**ADDENDUM NO. 2**

Plans and Specifications for: Waltham Park Improvements Project : Logan Park  
Location: Waltham, MA

Project Title  
 LOGAN PARK IMPROVEMENTS – CITY OF WALTHAM

SK L-3

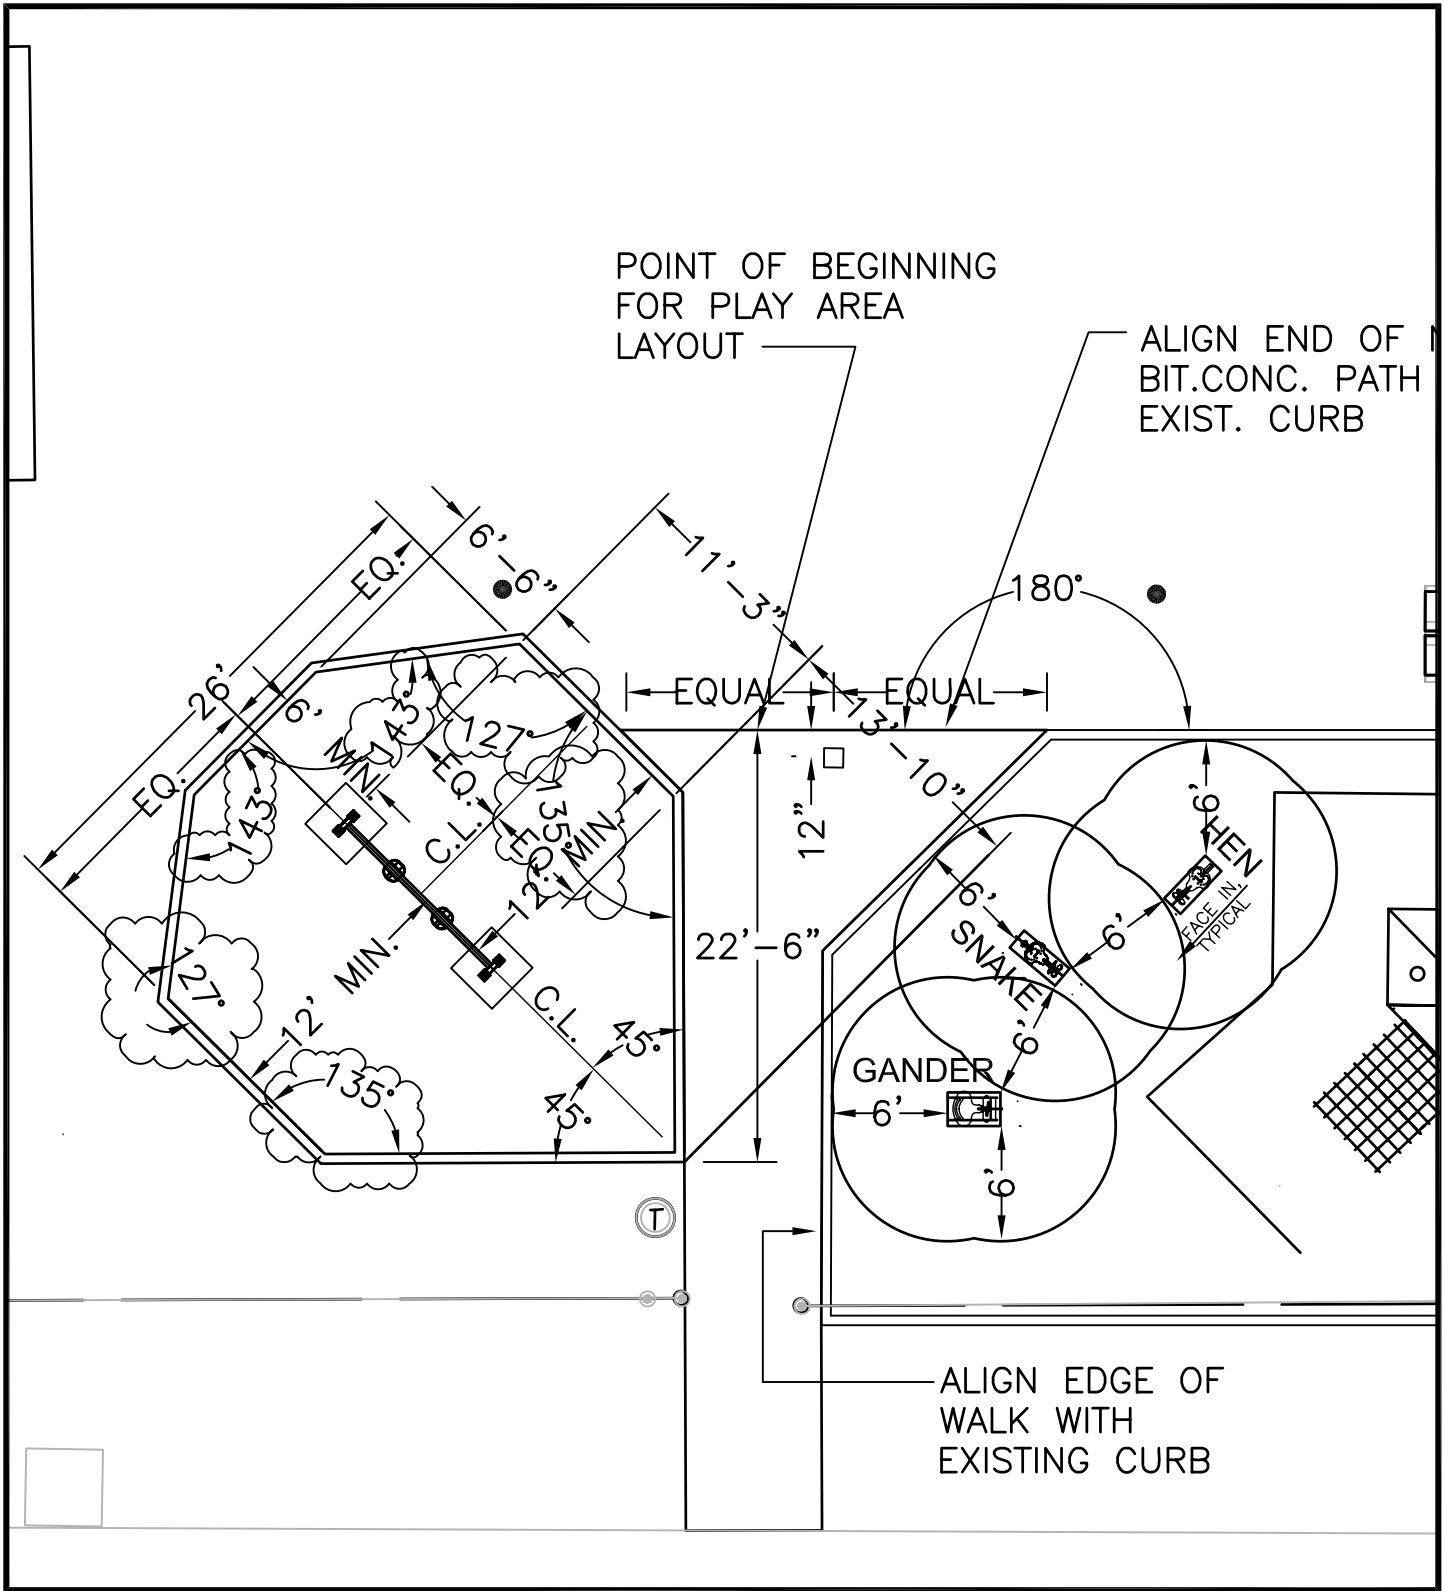
Q4. What is the size of plant materials noted on Layout and Materials Plan?

A4. *Refer to Plant Schedule included as SKL-5.*

<b>PLANT SCHEDULE</b>					
SCIENTIFIC NAME	COMMON NAME	SIZE	QUANTITY	SPACING	COMMENTS
<b>TREES</b>					
Ulmus americana "Valley Forge"	Hybird American Elm	4"-4-1/2" Cal.	1	See Plan for Location	B&B;6'-8" lowest branch height
Prunus serrulata "Kwanzan"	Kwanzan Cherry	3"-3-1/2" Cal.	1	See Plan for Location	B&B

Drawing Title  
 REVISION TO L-4 LAYOUT PLAN: ADDITION OF  
 ANGULAR DIMENSIONS AT PLAY AREA

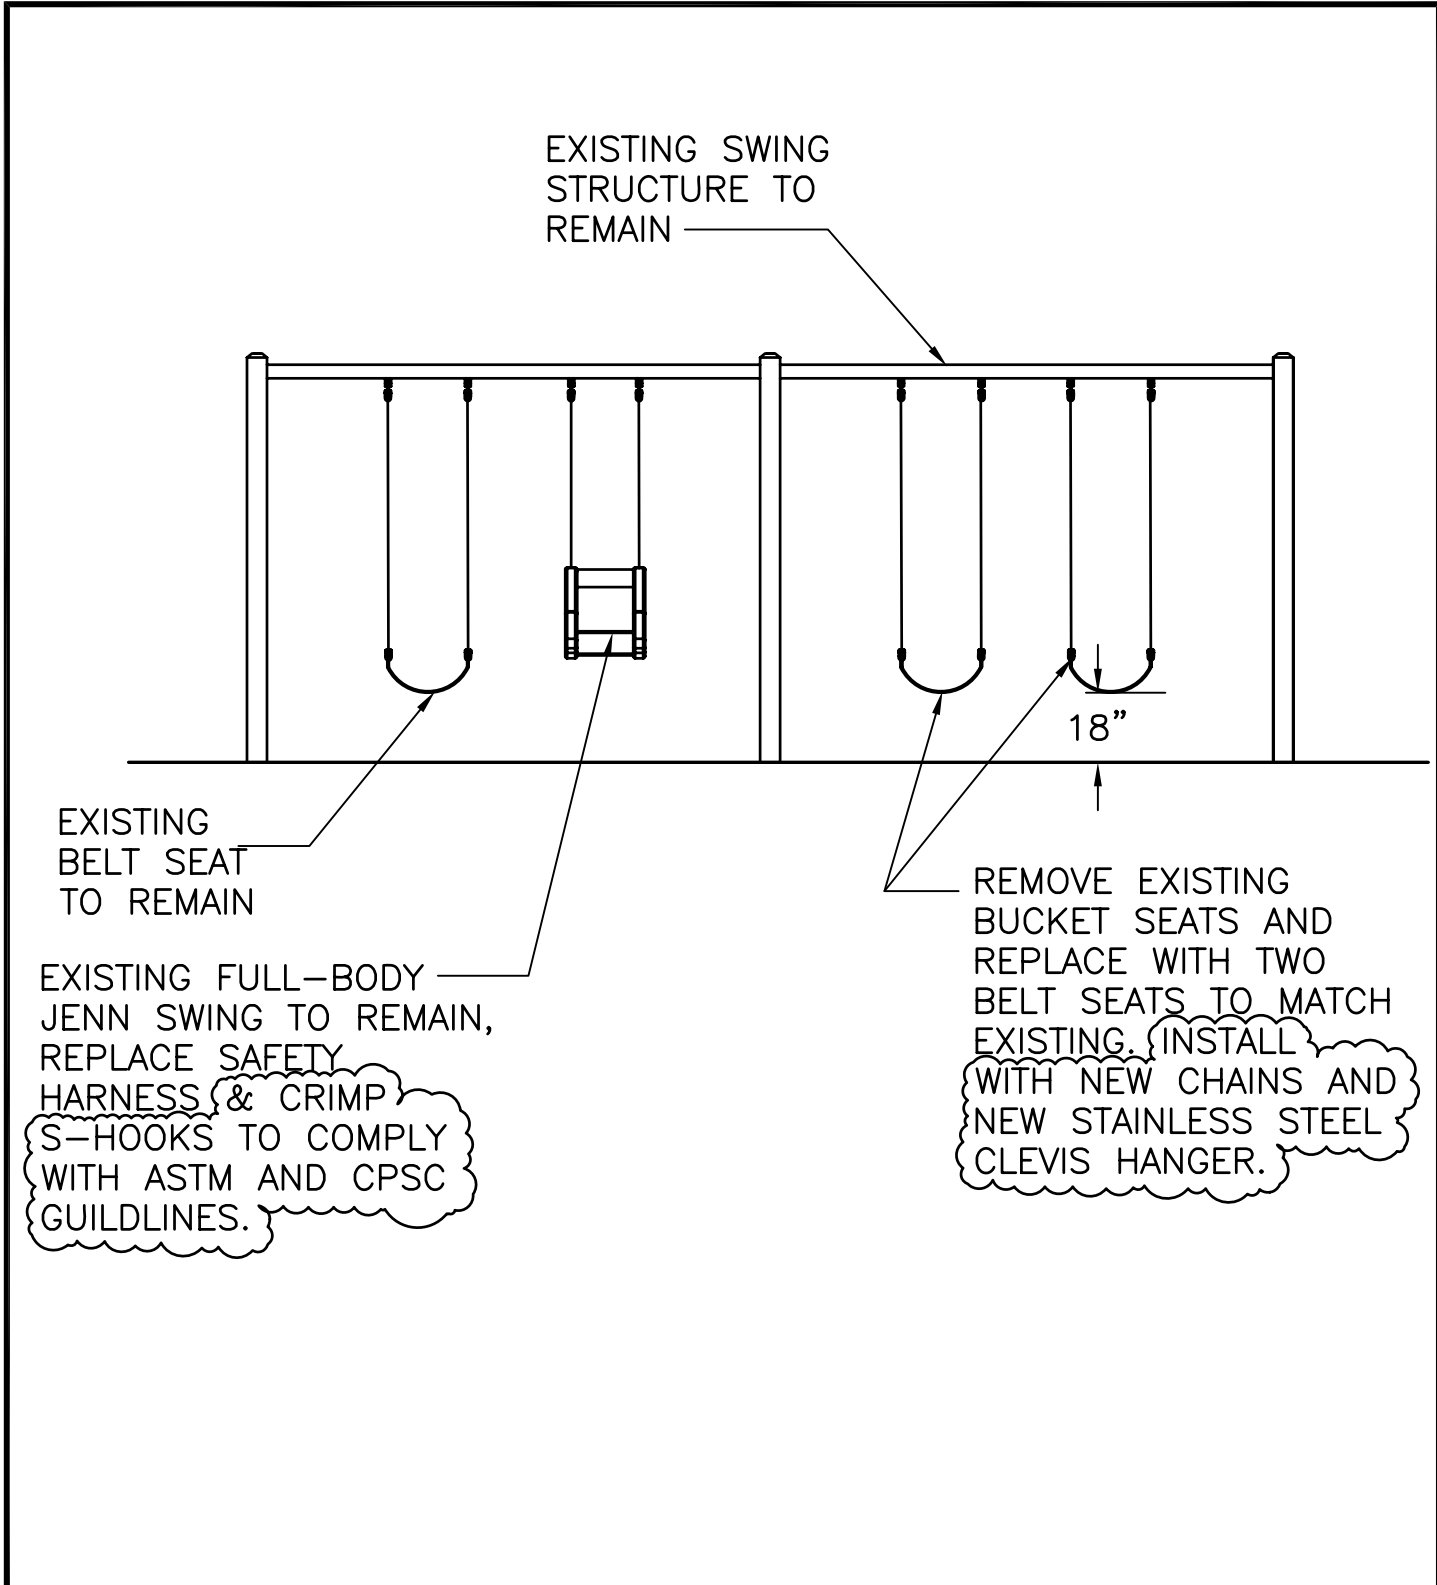
Q6. For the precast concrete curbing at the new play area, is a precast angle piece acceptable?

A6. *A precast angle piece is acceptable. CCA has provided a layout plan with angles. Refer to SKL-6.*

Drawing Title  
 REVISION TO L-7 DETAIL 6 – PARK SIGN & FOOTING

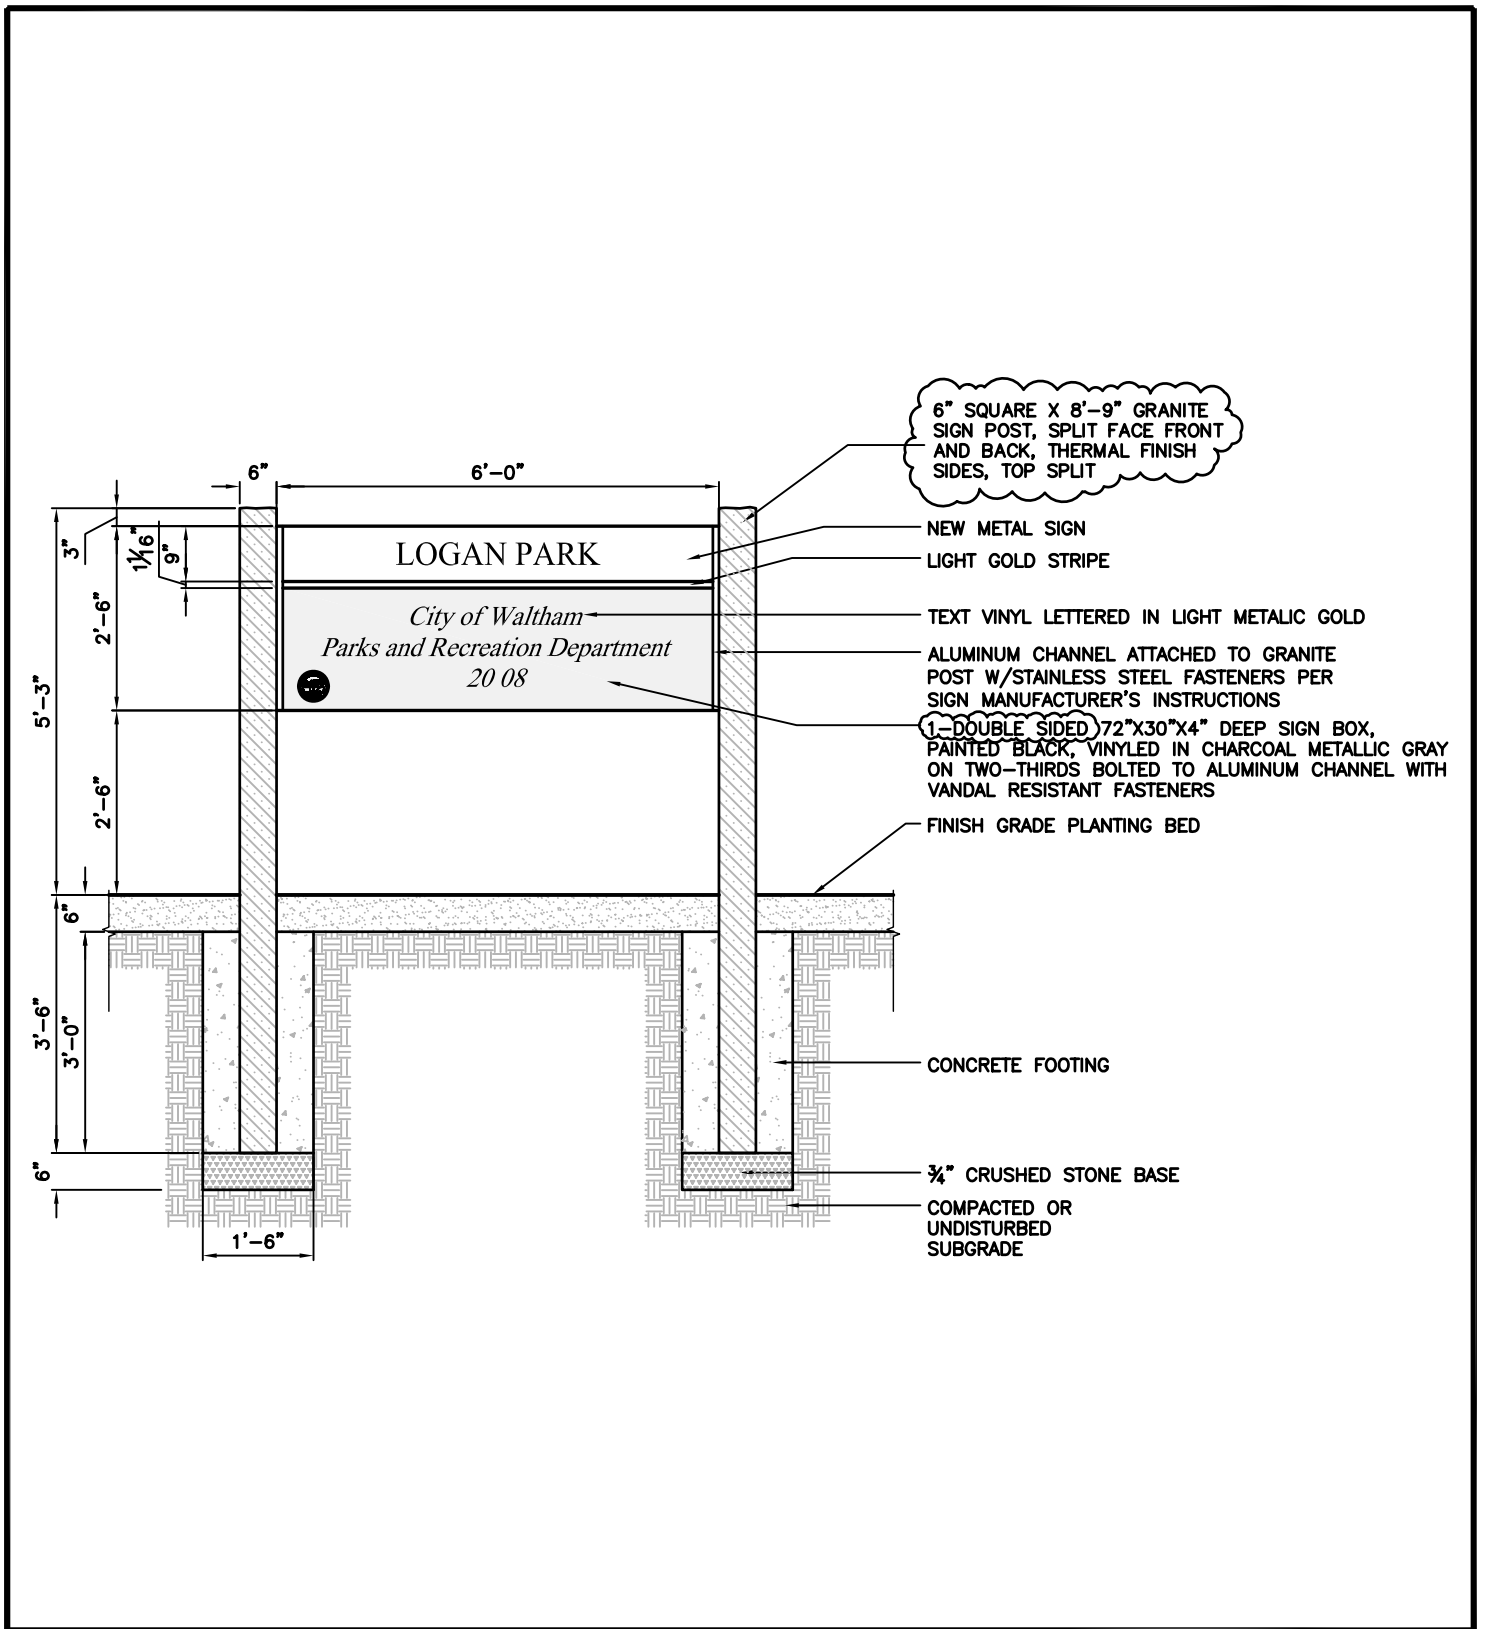
Item 2: Revision to specifications SECTION 10430, EXTERIOR SIGNS & PLAQUES

**Delete** Paragraph 2.03A Granite Posts.

“2.03 GRANITE POSTS

- A. Granite shall be furnished by the sign vendor.
- B. Granite shall be “Woodbury Grey” as supplied by Swenson Granite Works, 10 Main Street Route 109, Medway, Massachusetts 02053, (508)-533-2882 (Fax 508-533-344), or “Chelmsford Gray” as supplied by Fletcher Granite Company, 534 Groton Road, Westford, MA 01886, (978)-251-4031 (Fax 978-251-8773), or approved equal. Granite shall be supplied by a source approved by the Architect.

- C. Granite shall conform to the requirements of ASTM C 515, Architectural Grade and NBGA Specifications except as modified herein.
- D. Granite shall be standard grade, free of cracks, seams, starts, or other defects which may impair its strength, durability, or appearance. Exposed surfaces shall be free from spots, spalls, chips, stains, discoloration, or other defects which would affect its appearance. Color, texture, and finish shall be within the range of samples approved by the Architect.”
